### **ORDINANCE AMENDMENT REVIEW SHEET**

<u>Amendment</u>: C20-2019-008 University Neighborhood Overlay – Allowable uses, building heights, parking requirements, and sign regulations.

**Description:** Amend certain provisions of the City Code relating to provisions of the University Neighborhood Overlay (UNO) concerning use regulations, building heights, parking requirements, and sign regulations.

University Neighborhood Overlay Planni Additional Height & Affordability

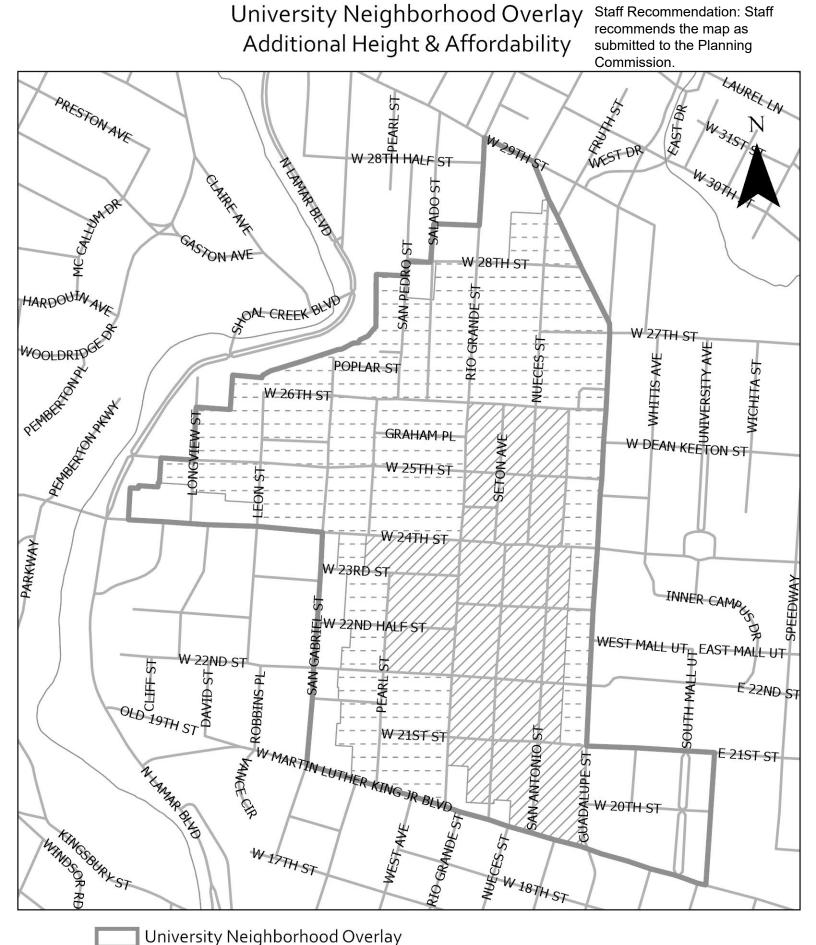
Staff does not recommend the changes
		Appendix C (University Neighborhood Overlay District Boundaries, Subdistrict Boundaries, and Height Limits)	The changes made by the PC were not among the amendments forwarded to them from the Codes and Ordinances Joint Committee.
3	Appendix C (University Neighborhood Overlay District Boundaries, Subdistrict Boundaries, and Height Limits)	3A. Planning Commission recommended amending the Subdistrict Boundaries map to expand the Inner West Campus Subdistrict boundaries. See page 5 of this report.	Staff believes that the significant impacts of the Planning Commission's recommendations need to be studied and subject to a broader community conversation involving residents,
		3B. Planning Commission recommended amending Amend the Height Limits map to expand the 175 foot height district. See page 7 of this report.	property owners, business owners, Greek organizations, and nearby neighborhood and community organizations. There is community opposition to the Planning Commission's recommendation.

Planning Commission changes are indicated by a red outline on the maps.	See original maps on pages 6 and 8 of this report.

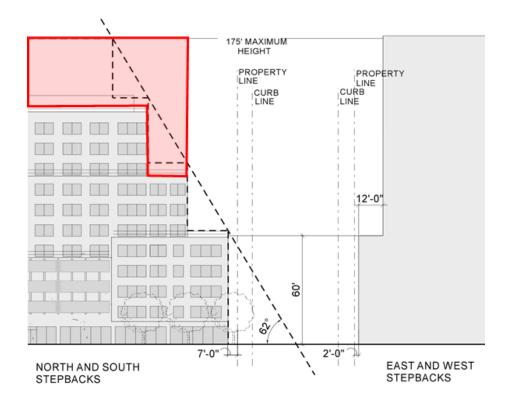
This illustration is taken from the "University Neighborhood Overlay Design Guidelines" in the *Central Austin Combined Neighborhood Plan*. The proposed amendment would remove the stepback requirements and allow a building to rise to the maximum height of 175 feet (shaded area) after the first stepback as illustrated by the building on the right side of the graphic.

Amend.	Existing Regulation	Planning Commission Recommendation	Staff Recommendation/Comments
#		Building Heights (continued)	
4	Heights: 25-2-758 (B)(2) If the north side of a building is adjacent to a street other than an alley and is greater than 65 feet in height, the upper portion of the north side of the building must be set back within a building envelope that is formed by a plane that extends from a point on the property line 65 feet high toward the building at an angle of 62 degrees above horizontal.	The proposed amendment would strike Code section 25-2-758 (B) (2).	Staff concurs with the Planning Commission Recommendation 25-2-758 (B) (2) was originally intended to reduce shadows and allow sunlight to penetrate to the ground on the Winter Solstice. However, for north-facing properties in Inner West Campus, this Code provision would preclude these sites from taking advantage of the additional height for the proposed amendments to Section 25-2-756.
